**TRANSMITTAL OF DENNIS WILLIAMS'  
COMMENTS ON WATERMASTER'S  
LONG TERM PLAN**

**Expert Report of  
Dennis E. Williams Ph.D.**

**COMMENTS ON CHINO BASIN WATERMASTER'S  
PROPOSED LONG TERM PLAN FOR THE  
MANAGEMENT OF SUBSIDENCE IN MZ-1**

**Figure 10**

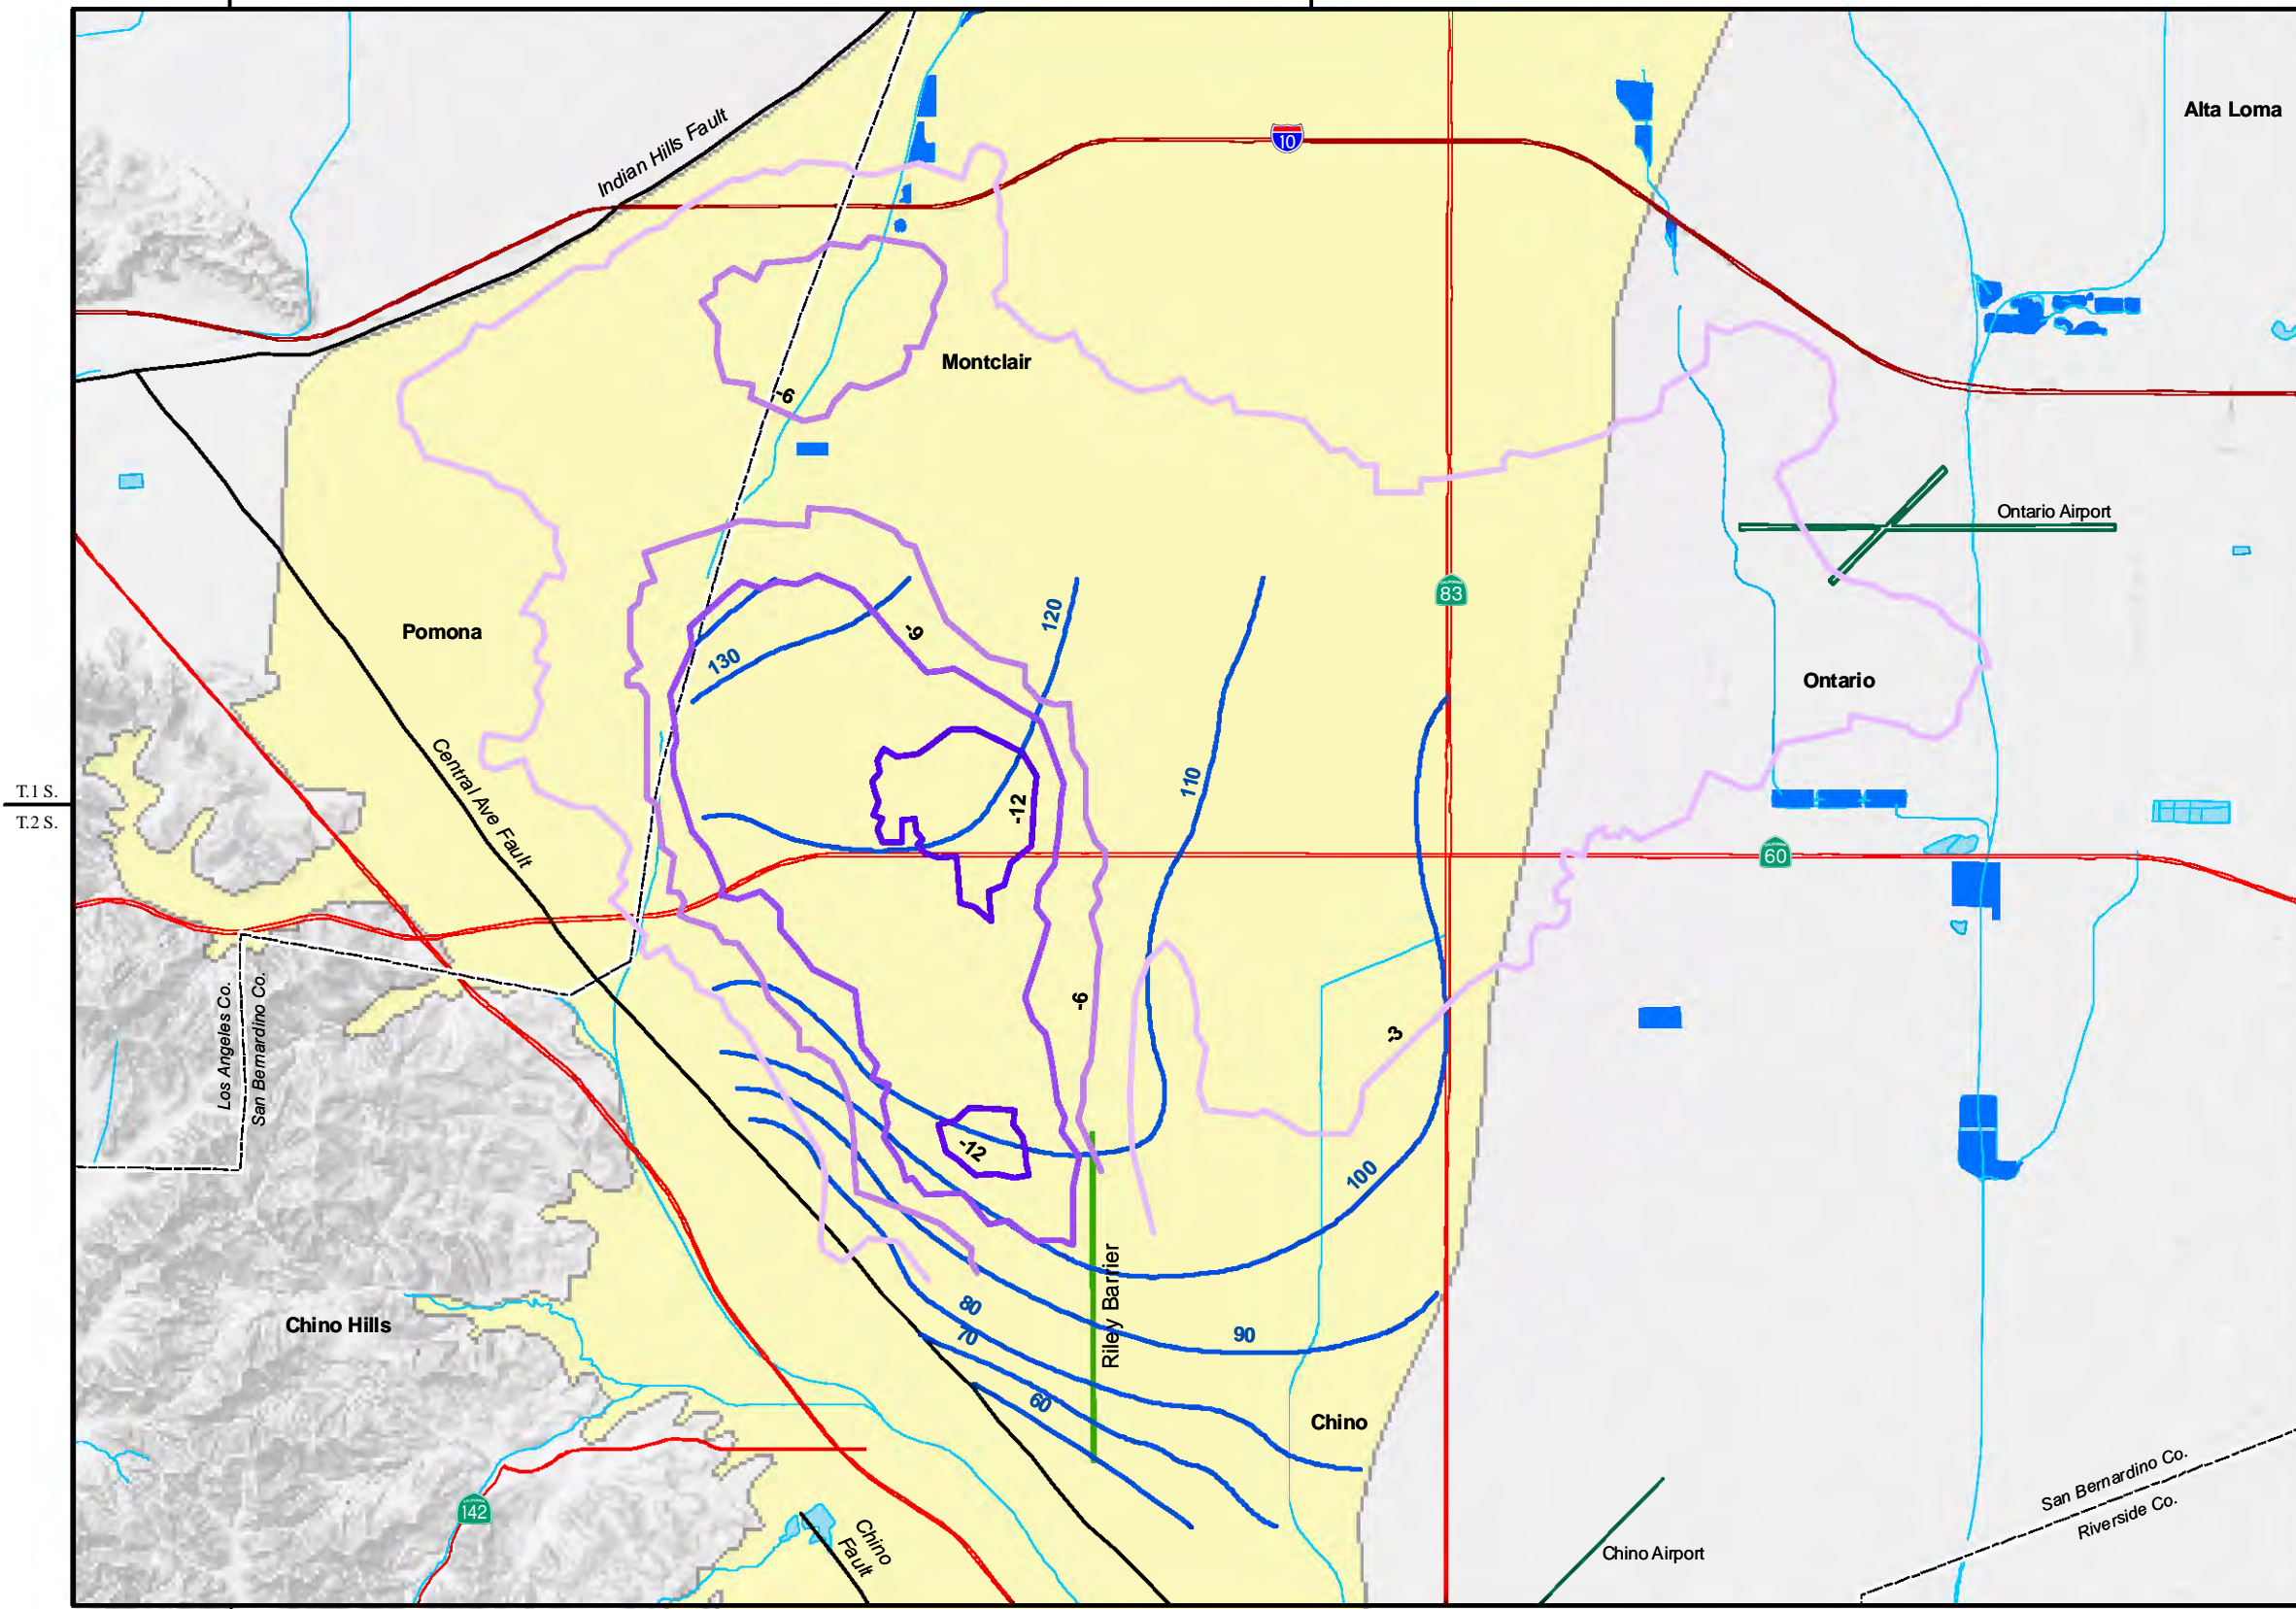
1            *InSAR analysis (see Figure 10). This area may be experiencing a delayed response to*  
2            *the long-term lowering of ground water levels in the MZ-1 area. This delayed response*  
3            *hypothesis should be verified through continued monitoring of surface and subsurface*  
4            *deformation (e.g., land surface surveys, extensometers and InSAR analyses).*

Figure 17

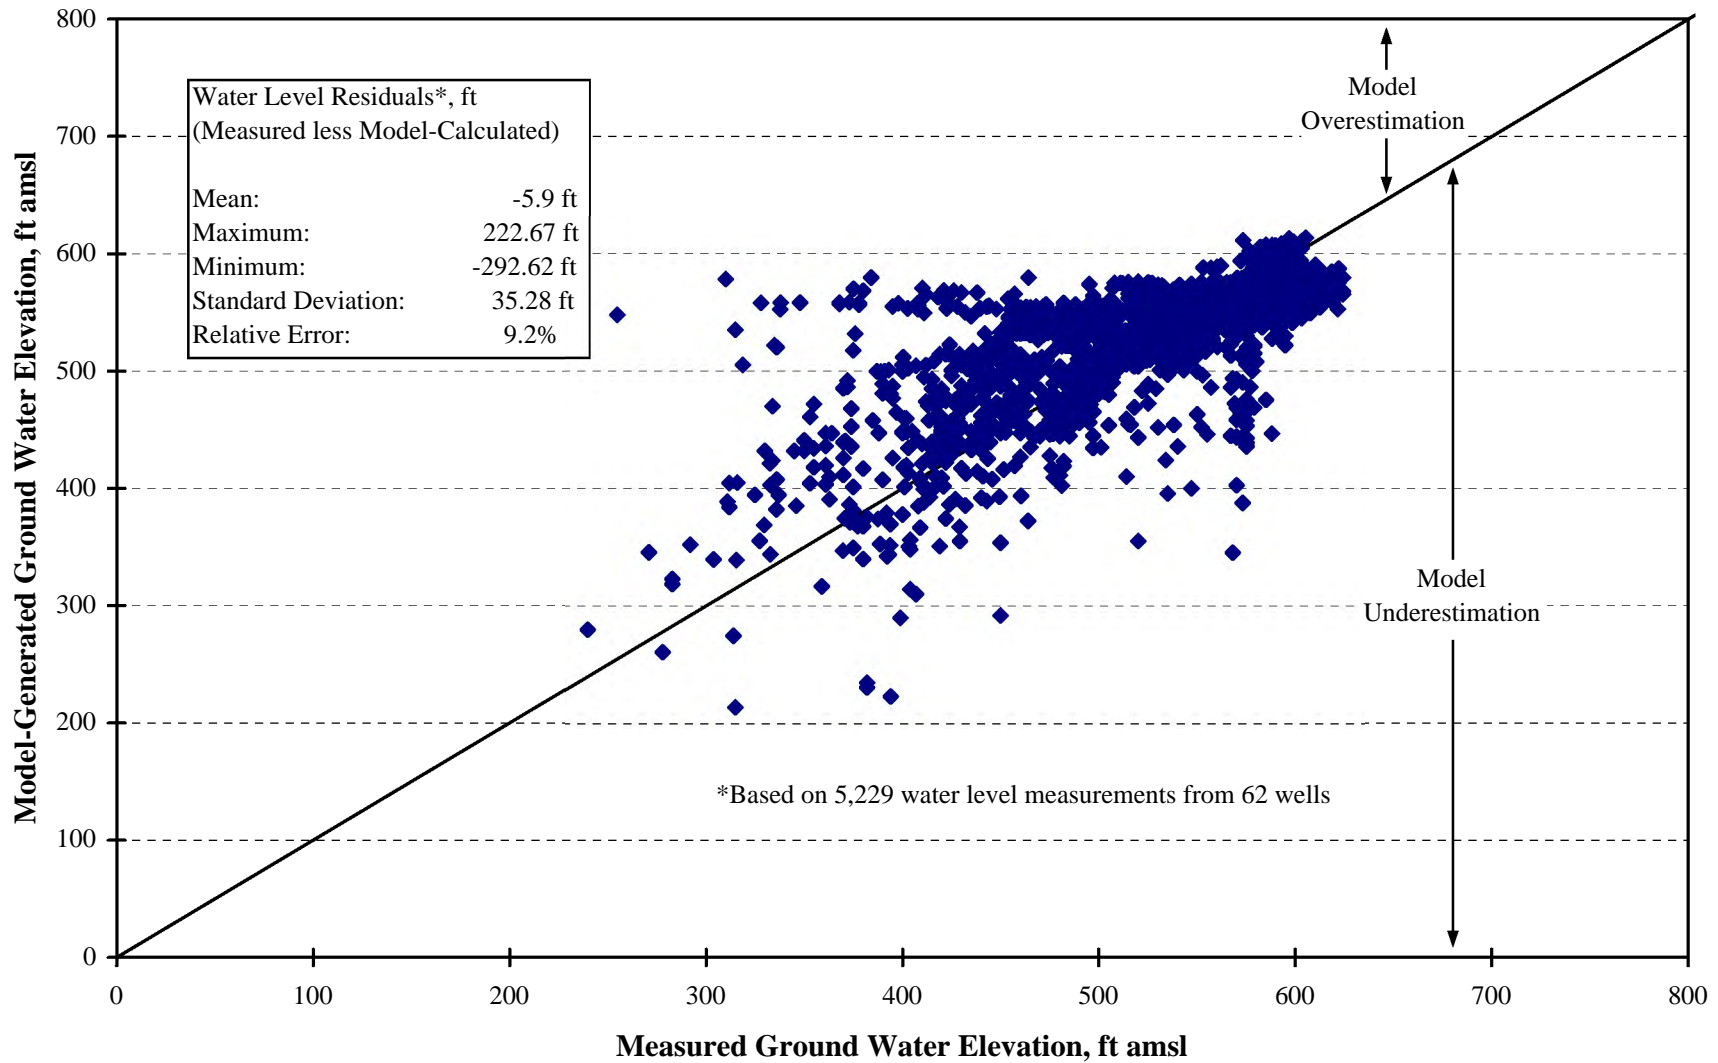
110. Figure 17 is an "x-y" plot showing a comparison of measured and model-generated ground water levels. The graphical comparison between measured and model-predicted heads (from 62 target wells) for the transient calibration shows the 5,229 ground water level measurements mainly clustered around the straight line. Some

Figure 18

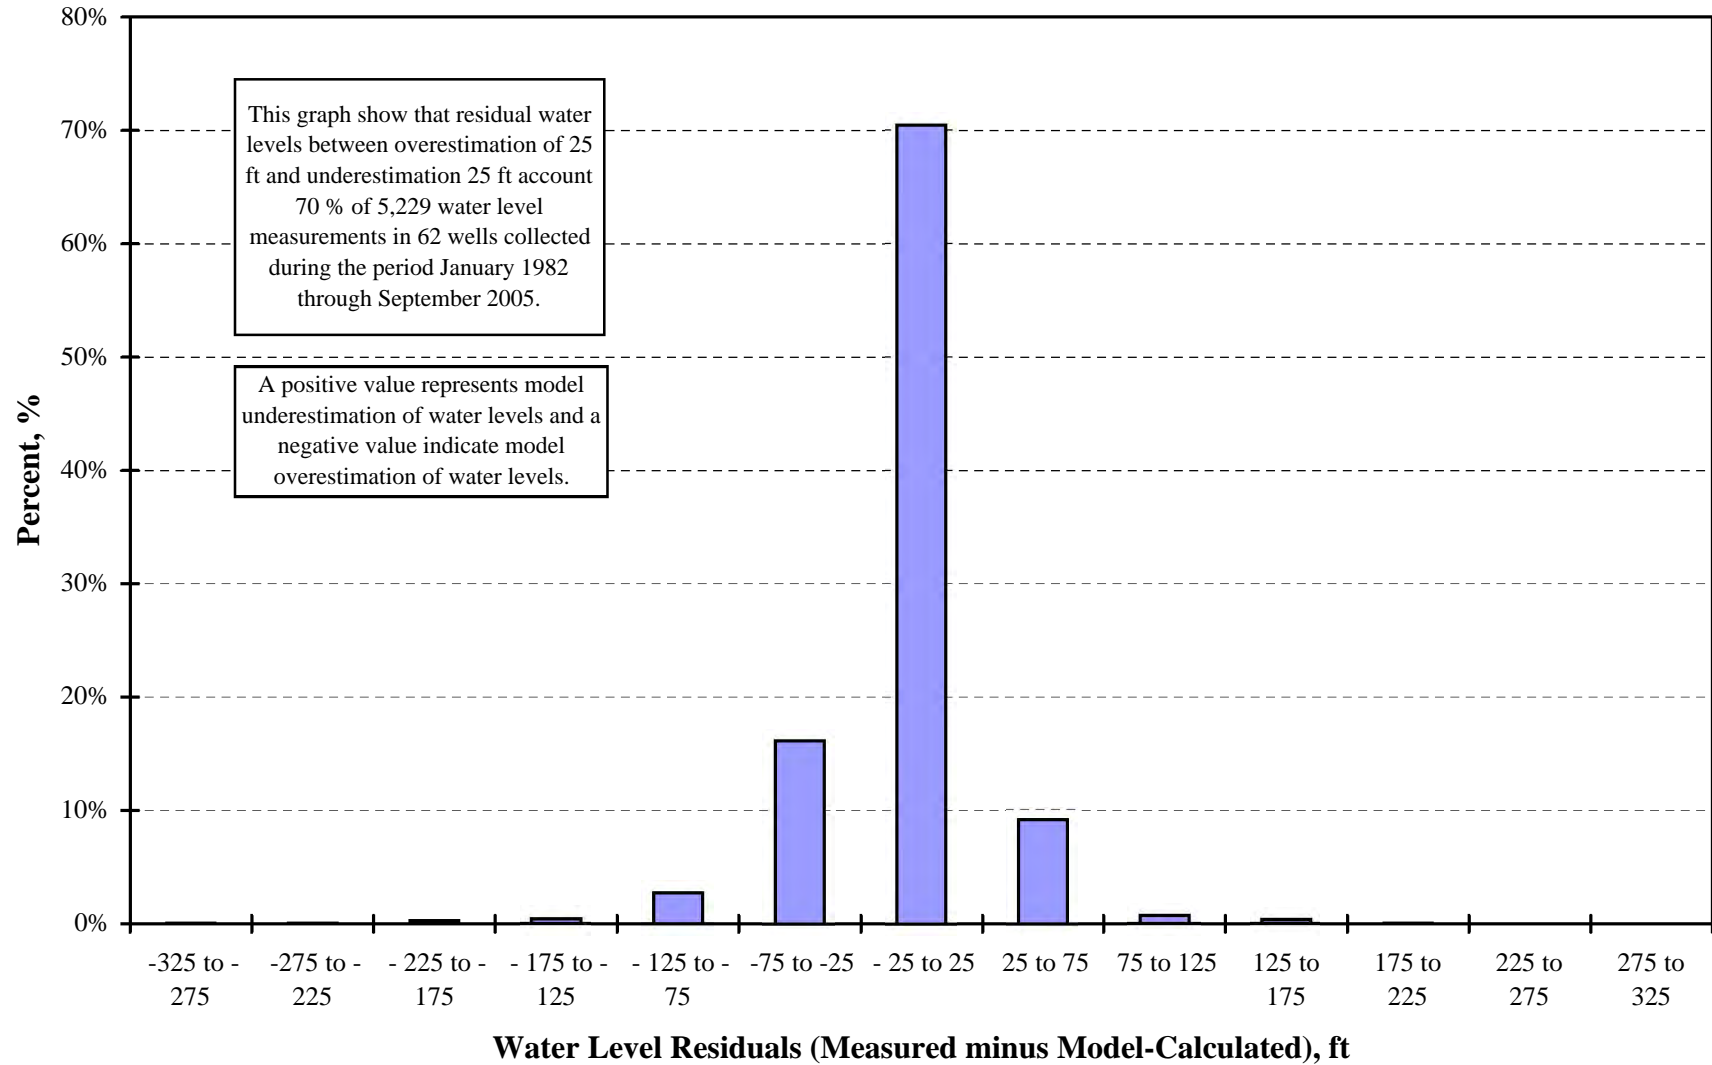
12  
13 111. Residual water levels for the 5,229 measurements from the 62 target wells during the  
14 period from January 1982 through September 2005 were plotted as histograms (see  
15 Figure 18). The histograms show a bell shape with most of the water level residuals in  
16 the range of +/- 25 ft (70% of the measurements), indicating an acceptable model  
17 calibration.

**Figure 19**

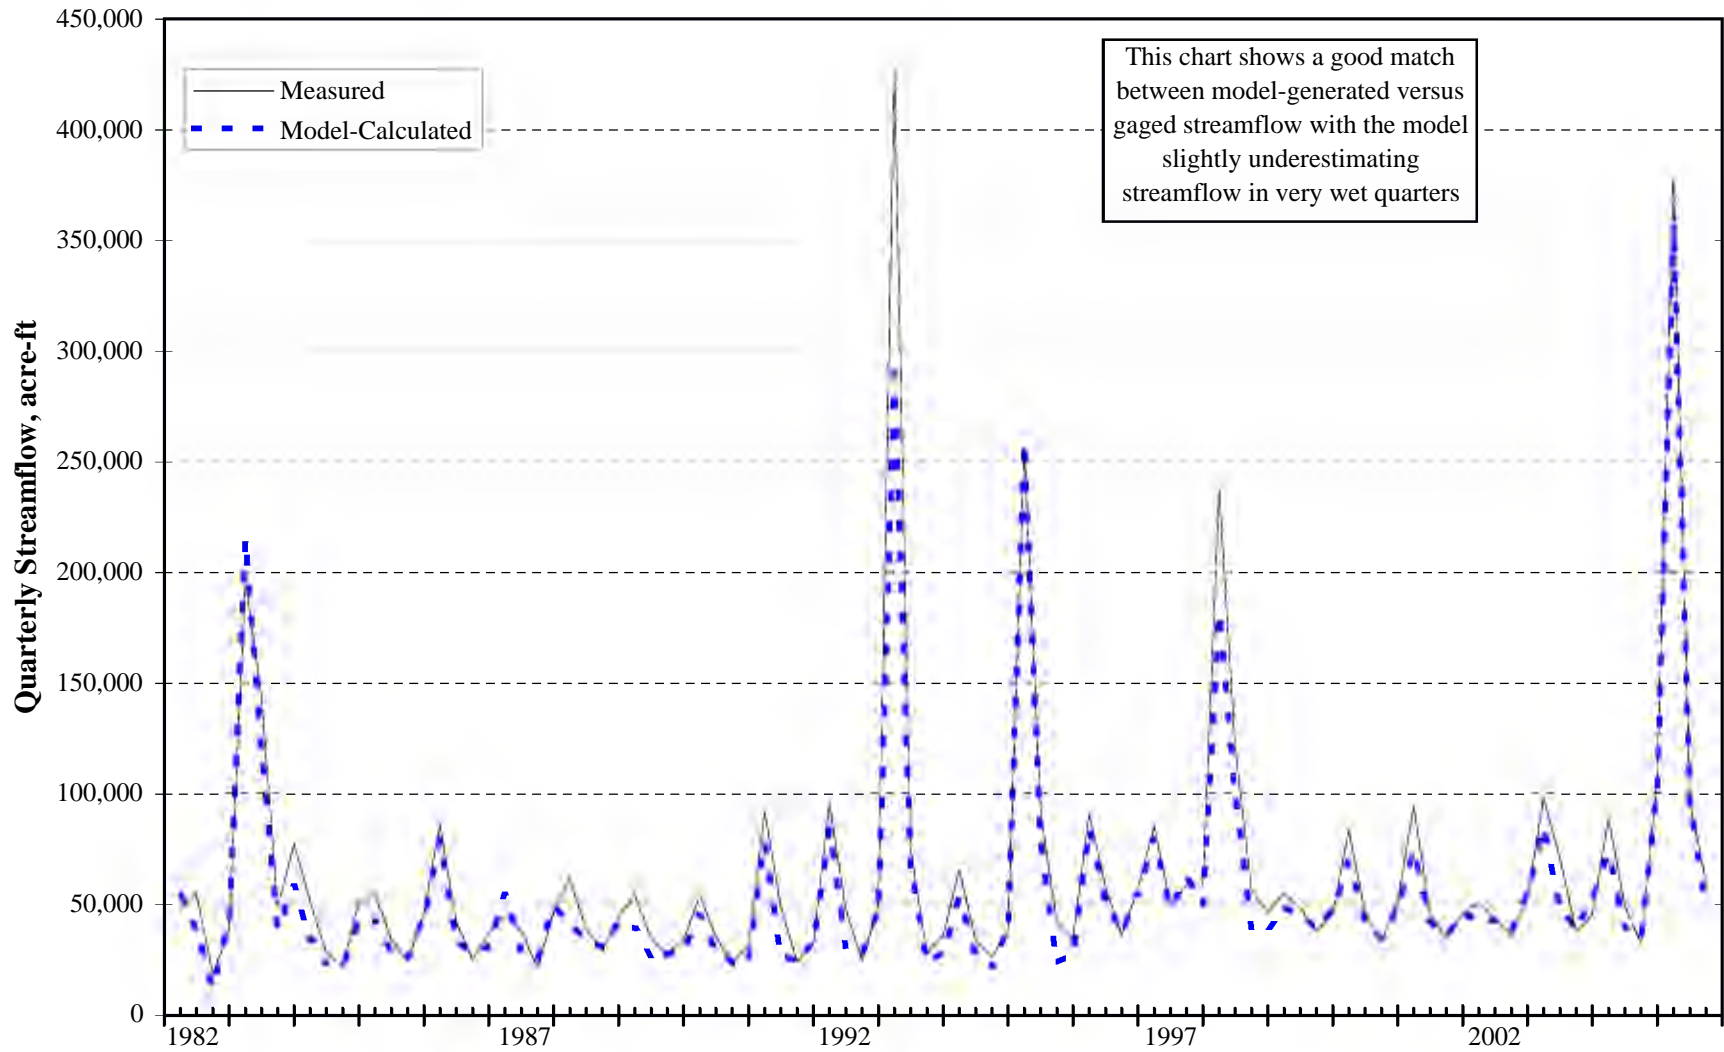
18  
19 112. A comparison of model-generated quarterly streamflow at Prado Dam with gaged  
20 outflow at the USGS gage just downstream of the Prado Dam is shown on Figure 19.  
21 This comparison shows a good match of model-generated versus gaged streamflow  
22 with the model slightly underestimating streamflow in very wet quarters.
